Nº 137 SERVICE BULLETIN

SUBJ: Austin Powers CPU Game ROM v3.01 Bug.

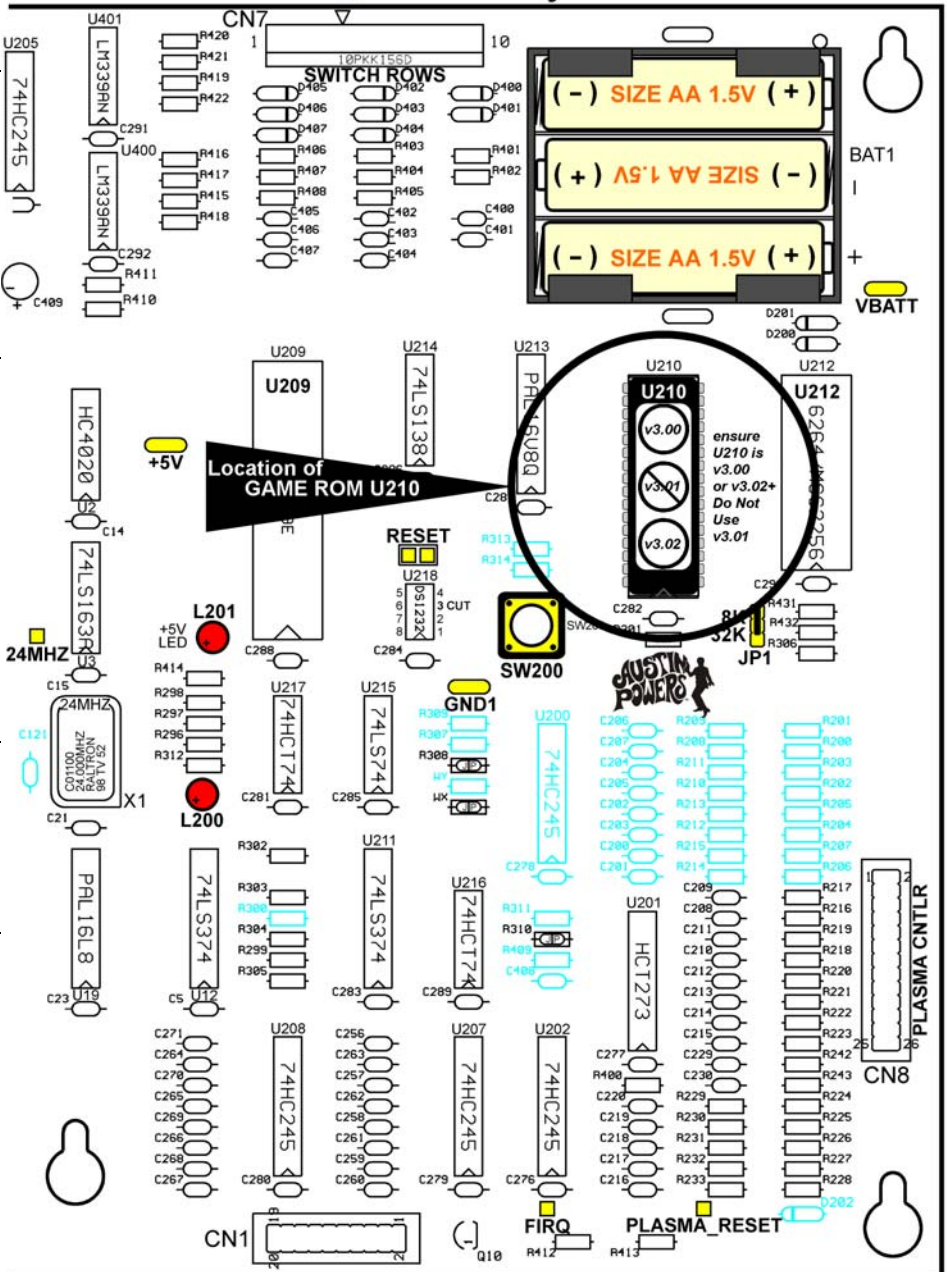
With CPU/OPSYS EPROM (Game ROM) **U210 v3.01** in place on the CPU/Sound Board: If the player does not achieve (score) the **Skill Shot*** and the ball subsequently drains, the ball will be put back in play repeatedly without advancing to the next ball. * **Austin Powers Skill Shot:** *The opening shot from the plunger at the beginning of each ball, closing either Top Lane Switch #47 or Switch #48.*

Replace only the **Game ROM** with v3.02 in the **U210** position on the **CPU/Sound Board**. This Game ROM is available from our distributors or can be downloaded for free from our web site. *To find a local distributor or to download, visit www.sternpinball.com.*
